International Isotopes Inc.

May 21, 2009

Subject: Response to NRC Request for Additional Information – Applications for Sealed Source and Device Registrations for Models BM10 and BMCY/BMNT Photon Emitting Sources.

Attachment 1 Drawing B1001000

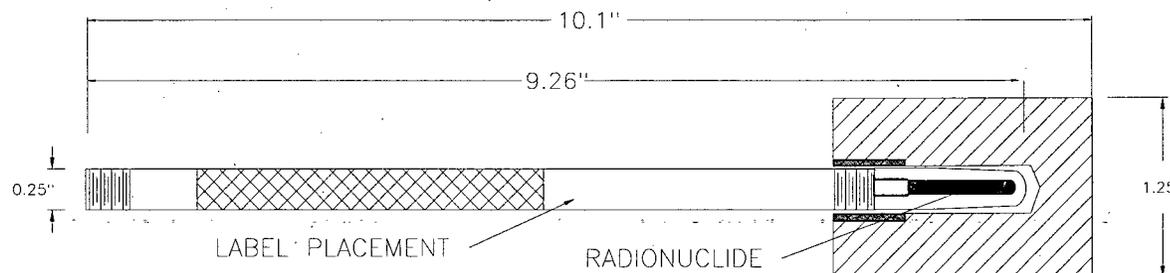
2.1. Please provide complete details of the labeling of the product, including information contained on the label and how and where the label is attached. Specifically, address whether the information is engraved or a separate label is attached on to the source. If attached, please describe the method of attachment.

- 5.1. Drawings B1001000, B1009001, and B003005 are labeled as proprietary. Please provide information as required by 10 CFR 2.390(4)(l)-(v) with regards to withholding this information from public disclosure and please include a notarized affidavit.

- 6.1. Please provide non-proprietary illustrations similar to drawings B1001000, B1009001, and B003005, preferably in electronic form, that are suitable for inclusion in the registration certificate.

Response to A. 2.1: Each source and storage shield is conspicuously labeled with the radioisotope, the activity, the reference date (MM/YY) a unique serial number, the radioactive tri-foil symbol and the words, "Caution Radioactive Material". The surface of this label material is a combination of rubber (latex) and paper. Below the surface is a thin film barrier coating to provide added strength. The material is flexible and water resistant. The label has an adhesive backing. Once applied to the source and shield a second clear label is applied over the data label to ensure the data remains legible throughout the life of the source. Refer to Drawing B1001000 for label placement. There is no intention to engrave the source.

In regards to handling and storage; the description of the source provided in the application as well as Drawing B1001000 indicates that the radionuclide is confined to the tip of the rod (the pointer). When not in use the pointer is threaded into the shield, this is the storage configuration. When the source is in use it is intended to be handled at the end opposite the pointer (the non-active end). The non-active end is threaded as well so that the shield can be threaded onto this end were it can act as a stand and to allow for the source to be handled comfortably in the palm of the hand. Note that a sufficient amount of distance between the pointer and the non-active end of the rod reduces the dose to the extremities when the source is being handled as intended with the pointer out of the shield. International Isotopes, Inc. distributes these sources to customers licensed by the NRC or an Agreement State or when sources are exported, licensed or authorized by the appropriate foreign authority.

Response to A. 5.1: Following careful consideration, INIS and RadQual, LLC agree that the details contained within the drawing can be released to the public. These drawings are provided containing a statement to this affect.

Response to A. 6.1: Comment addressed in Response to A.5.1. Also note that Drawing B1001000 is intended for inclusion in the registration certificate. Drawings B1009001 and B003005, while authorized for public disclosure were included in the application package as part of the testing documentation and are not applicable and should not be included in the registration certificate.

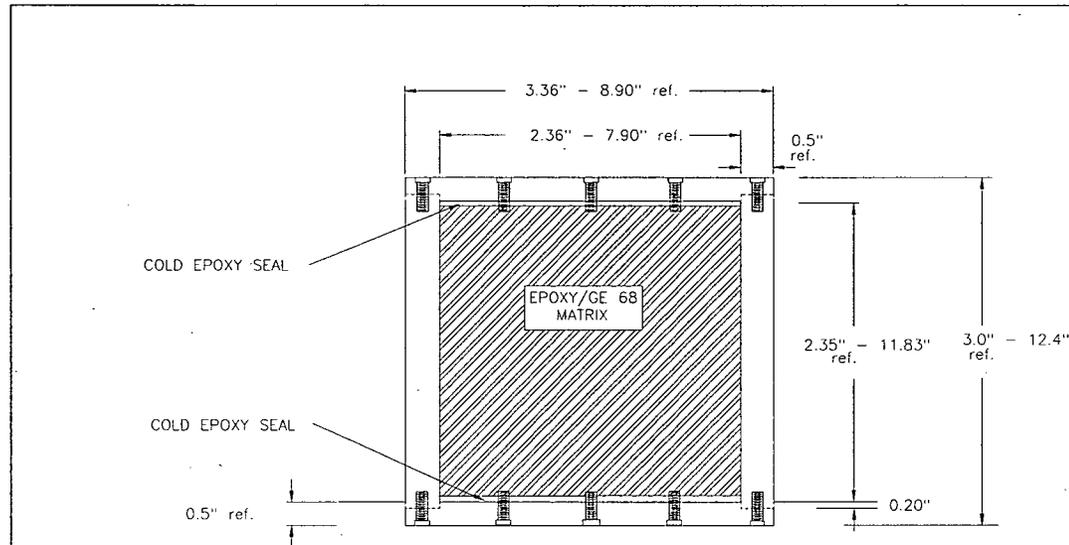
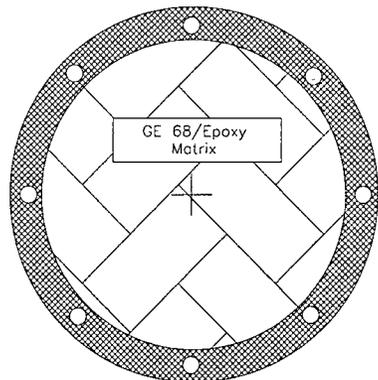
- 4.1. Drawings RAD020309-1 and B900101 are labeled as proprietary. Please provide information as required by 10 CFR 2.390(4)(1)-(v) with regards to withholding this information from public disclosure and please include a notarized affidavit.

- 5.1. Please provide non-proprietary illustrations similar to drawings RAD020309-1 and B900101, preferably in electronic form, that are suitable for inclusion in the registration certificate.

Response to A. 4.1: Following careful consideration, INIS and RadQual, LLC agree that the details contained within the drawing can be released to the public. New drawings are provided containing a statement to this affect.

Response to B. 5.1: Comment addressed in Response to B.4.1.
